**STAFF REPORT - SITE PLAN REVIEW**

Date: 9/25/2017		Planner: Ebony Mapp		Case No: C-76-17	
<b>PROPERTY &amp; APPLICANT INFORMATION:</b>					
Project Name/Proposed Use: 29 lot Single-Family Residential Subdivision PUD			Property Address: 500 block of Astor Place		
Applicant: Linwood Development, LLC			Owner: Linwood Development, LLC		
Prior Cases: C-69-07			Additional Requests: N/A (N/A)		
City Council District: E/Flurry			Parish Commission District: 10/Chavez		
<b>REVIEWED BY:</b>					
<input type="checkbox"/> Engineering – Streets & R.O.W. ( <input checked="" type="checkbox"/> N/A)		<input type="checkbox"/> Engineering – Stormwater & Drainage ( <input checked="" type="checkbox"/> N/A)		<input type="checkbox"/> Fire Prevention ( <input checked="" type="checkbox"/> N/A)	
<input type="checkbox"/> Caddo Parish Public Works ( <input checked="" type="checkbox"/> N/A)		<input type="checkbox"/> LA Department of Transportation ( <input checked="" type="checkbox"/> N/A)		<input type="checkbox"/> Alcohol Beverage Office ( <input checked="" type="checkbox"/> N/A)

**CASE NO. C-76-17: PUD ZONING REQUEST & PRELIMINARY SITE PLAN**

**Applicant/Owner:** LINWOOD DEVELOPMENT, LLC  
**Location:**

FOR:  
 BRUSHY BAYOU  
 PROPOSED PARK (0.63ACRES)

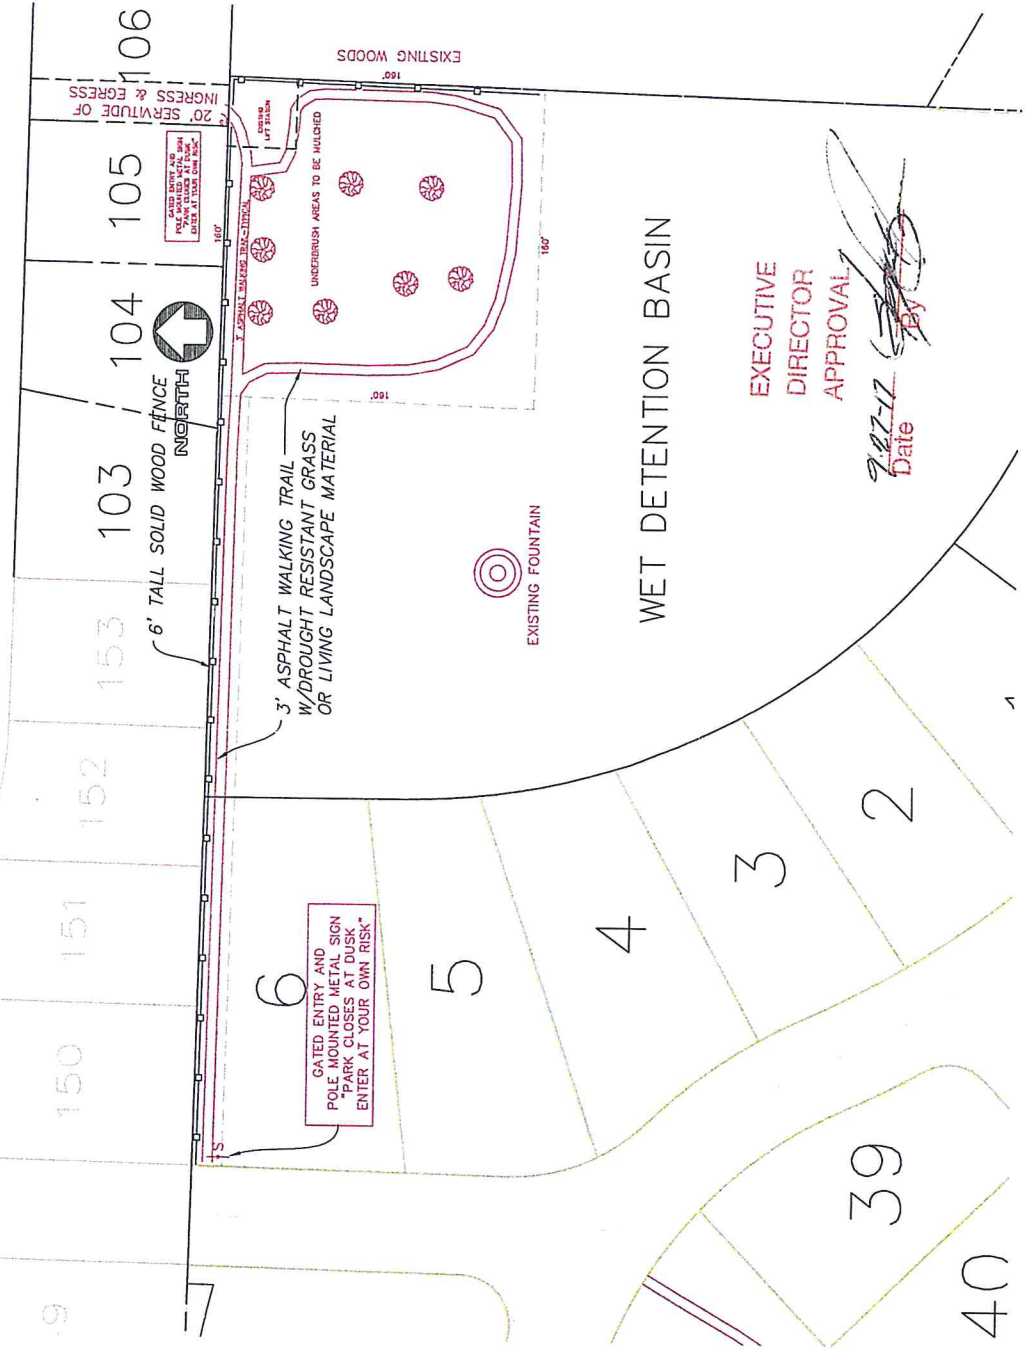
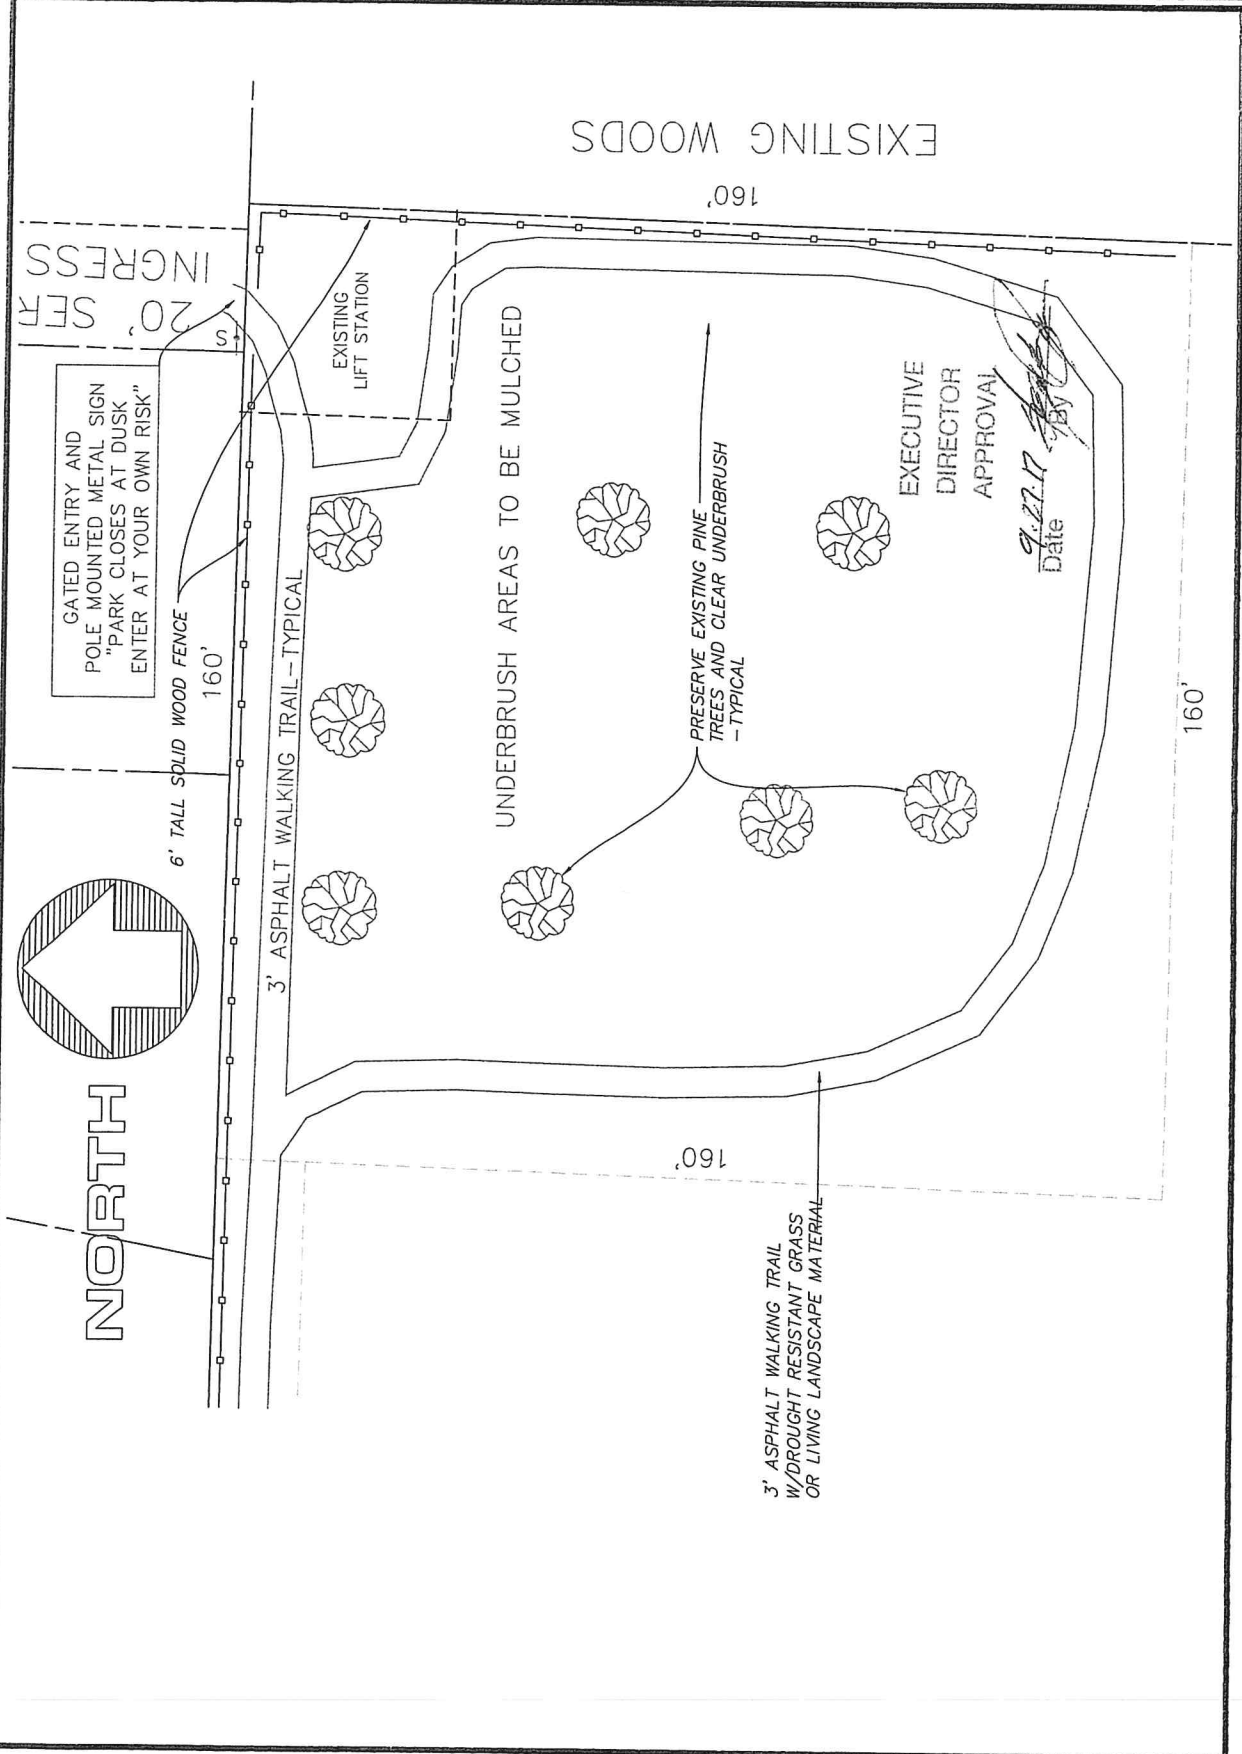
There is a detention pond with a fountain located to the south of both the proposed and existing units and is included in the preliminary site plan boundary. A 0.6 acre portion of the green space surrounding the detention pond is proposed as a pocket park. A 3' wide, 500' long looping asphalt walking trail will connect to a 15' wide access easement (entry path) stretching 400' to the unnamed roadway that connects to Mykanos Trail in Unit 8. An existing lift station sits at the northeast corner of the proposed park. A proposed 20' servitude is located between lots 105 and 106 in the existing development and will serve as a second connection between the nearest street, Mykanos Trail, and the walking trail within the pocket park.

It is important to note that the original plans submitted for the August 2<sup>nd</sup> MPC meeting included a number of amenities, which are not now reflected in the revised application, such as a fully enclosed pocket park and lockable gate, a walking trail at a width of 5', the addition of 14 large shade trees, a 1,200 SF pavilion and 3 metal benches that were later exchanged for two picnic tables and then removed from consideration by the applicant. The fencing around the entire pocket park was eliminated as a means to allow unobstructed views of the detention pond from the walking trail within the pocket park. Instead, a 6' wood fence is proposed along the rear of lots 152, 153, 103, 104 and 105 which back up to the detention and park area, and the eastern side of the park. The remaining items were eliminated from the proposed amenities by the applicant due to the applicant's assertion that the project will be financially infeasible without the removal and/or downscaling of these items.

The revised conceptual plan for the proposed pocket park includes a number of existing trees and underbrush. Instead of landscaping the site, the applicant has elected to keep the existing trees, remove the underbrush and replace it with mulch. While the inclusion of seeding or the provision of sod, along with mulch, would be preferred, the addition of mulch will add to the natural feel of the park and help protect the site from erosion. Staff asserts that drought resistant/low maintenance landscaping should also be added along the entry path from the road into the park and along the outer ring of the walking trail to provide erosion control and long-term maintenance of the property.

While the inclusion of a pocket park near the detention area is a logical pairing; the actual placement of the park presents a concern that is also worth mentioning. As planned, the park is situated at the rear of both the existing and proposed units and out of view from any of the roadways within the development. This arrangement, coupled with a lack of security measures to restrict access may serve to make patrons using the park especially vulnerable. This may be true regardless of the time of day; however, it would be particularly concerning at night. As a result, security is a major priority that cannot be ignored in considering this amenity.

The applicant intends to add a pole-mounted metal sign that warns patrons that the park closes at dusk and those that enter do so at their own risk. The inclusion of some type of signage is appropriate; however, even when coupled with the alternative access into and out of the park, these methods do little to safeguard patrons given the remote location of the park, especially for children. The addition of a lockable gate at both entrances and an extension of the 6' wooded fence to the roadway would go a long ways toward adding security to this space.

- Approval of the requested ordinance relief along with the proposed amenities as documented in this report and as shown in the attached concept plan for the proposed pocket park and pedestrian walking trail, but with the following revisions: (1) show drought resistant grass or other living landscaping material provided along the entry path and outer ring of the walking trail; (2) show an extension of the 6' solid wood fence along the entry path to the unnamed roadway that connects to Mykanos Trail, and (3) provide a gated entry at both entrances with access hours posted for patrons;

- Approval of the requested ordinance relief along with the proposed amenities as documented in this report and as shown in the attached concept plan for the proposed pocket park and pedestrian walking trail, but with the following revisions: (1) show drought resistant grass or other living landscaping material provided along the entry path and outer ring of the walking trail; (2) show an extension of the 6' solid wood fence along the entry path to the unnamed roadway that connects to Mykanos Trail, and (3) provide a gated entry at both entrances with access hours posted for patrons;
